NYISO Voltage-constrained Transfer Limit Analyses

Con Edison assessment of "I to J Transfers" Voltage @ Sprain Brook

VOLTAGE L/O W89&90 TOWER

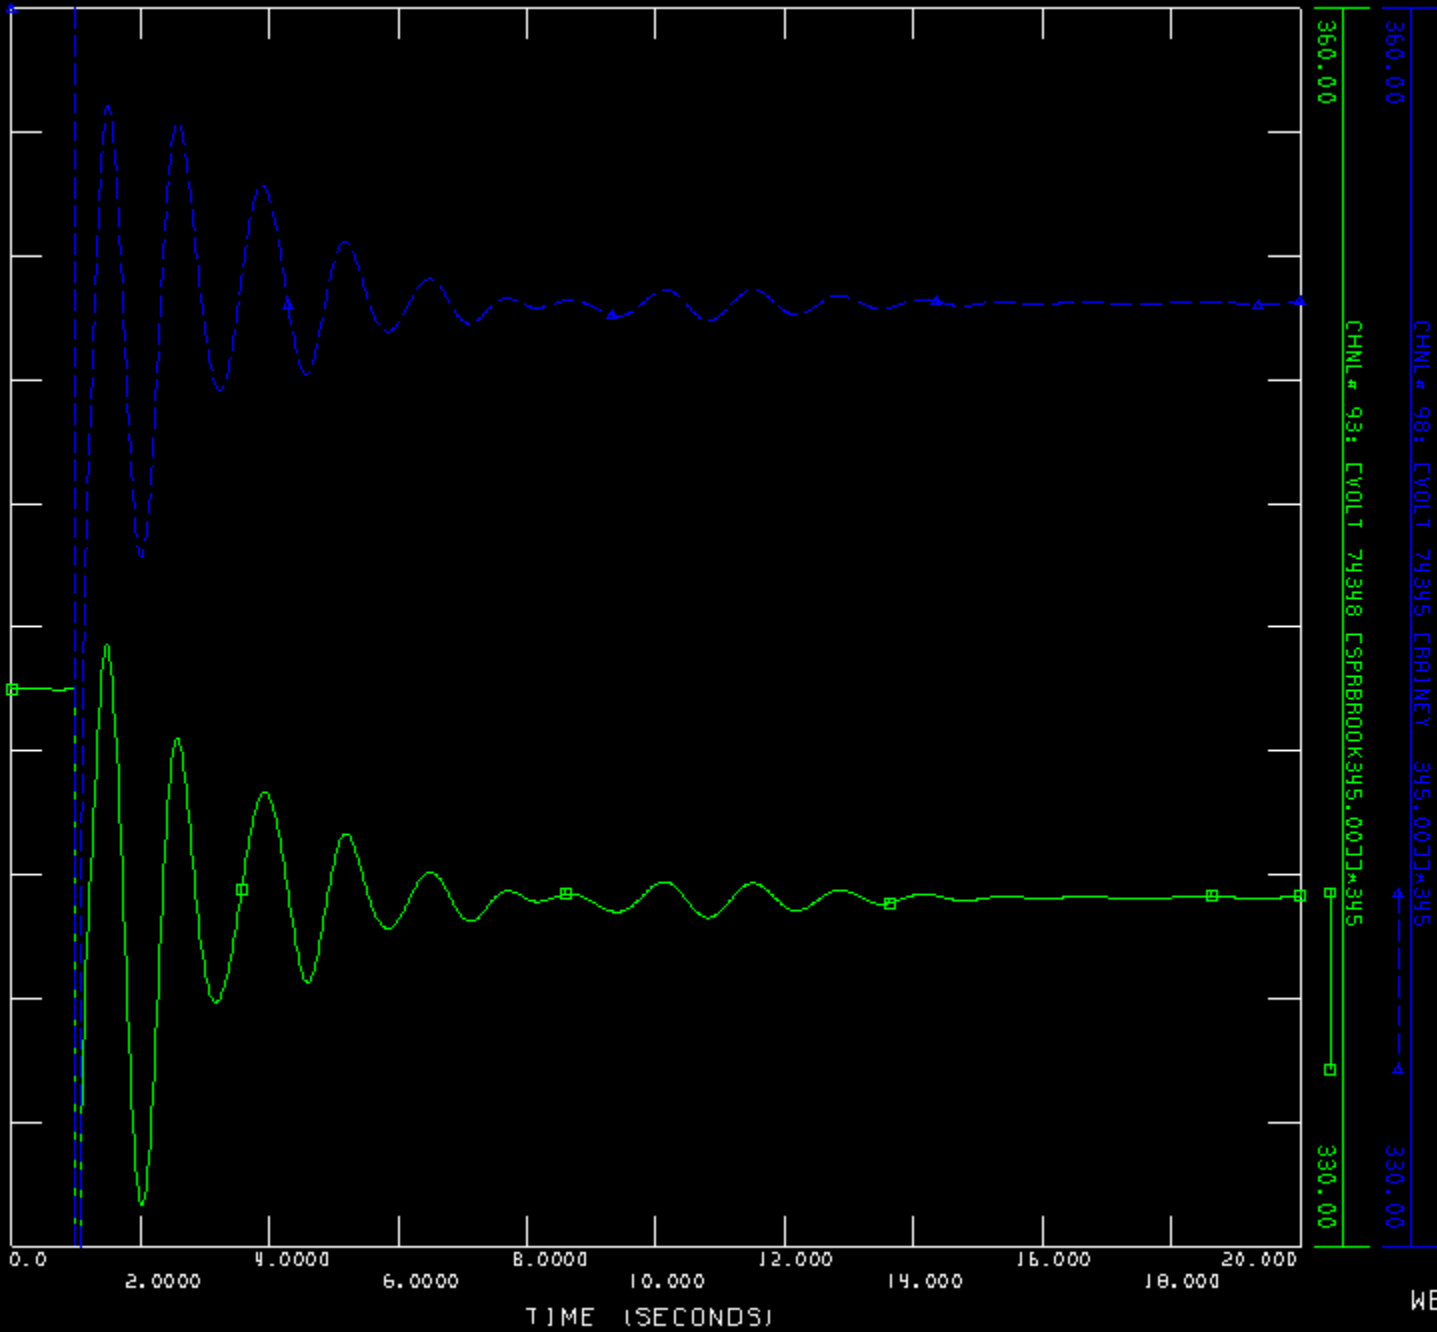
- **Voltages monitored 30-60 seconds after the contingency occurs**
- **Recognizes only the automatic response of the system:**
 - Generators' excitation & governor systems
 - SVC contribution
- **Other (slower-acting) controls frozen**
 - PARs and LTC transformers fixed at their pre-contingency solved tap position
 - Transmission switched shunts are locked
 - DC terminals locked
 - Operators' actions (e.g. dispatching/committing generation – ramping steam units, turning on GTs)
 - Area Interchange disabled
- **Load represented as constant power (except for Con Ed loads)**
- **The above conditions describe post-transient conditions best evaluated via 6 stability simulations**

<u>NYISO voltage criteria</u>	<u>NYISO power flow solution</u>	<u>Stability solution</u>
1. Generators' Excitation system action	<u>Not</u> represented	Represented
2. Generators' Governor system action	<u>Not</u> represented	Represented
3. SVC action	Represented	Represented
4. Load model	Constant MVA	Constant impedance
5. No other operator action	Yes	Yes

VOLTAGES

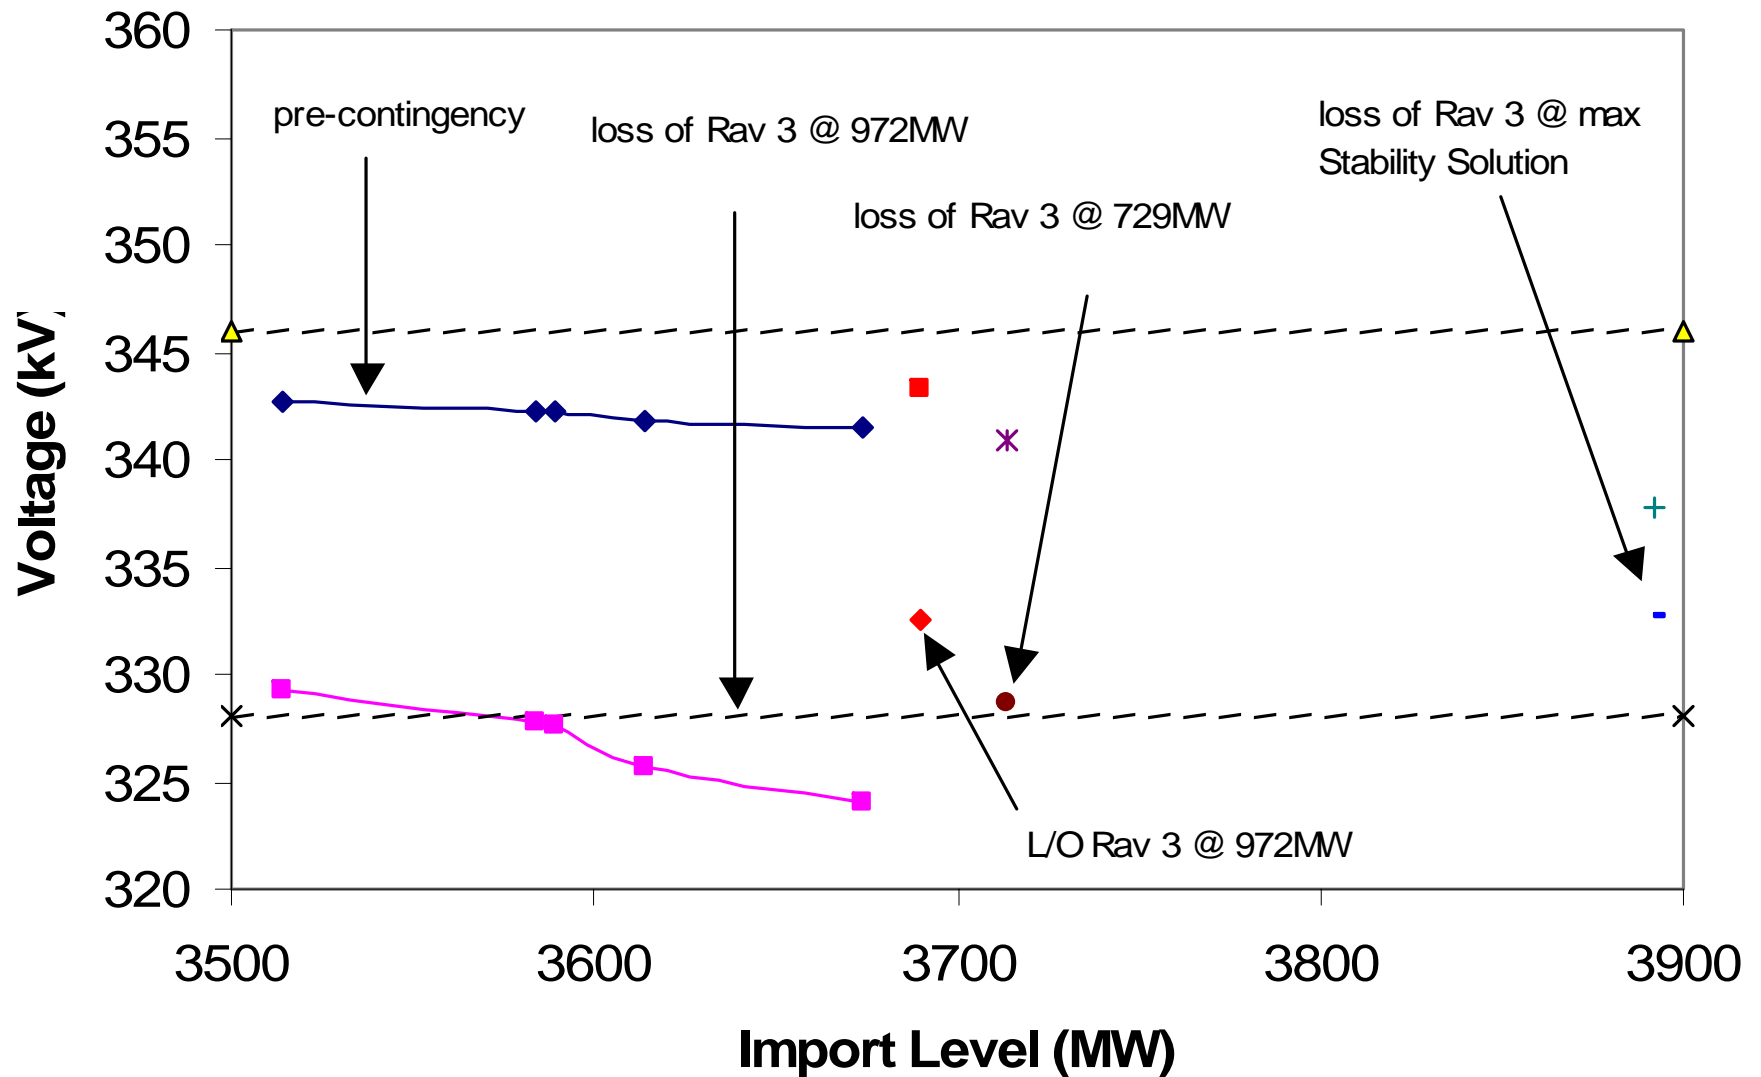
Summer 2006 - I to J transfers at 3680 MW

Ravenswood #3 at max. output: 972 MW
 (the NYISO calls 3300 MW the limit on I-to_J transfers)

Post-contingency solution used is the NYISO's approximate power flow solution.
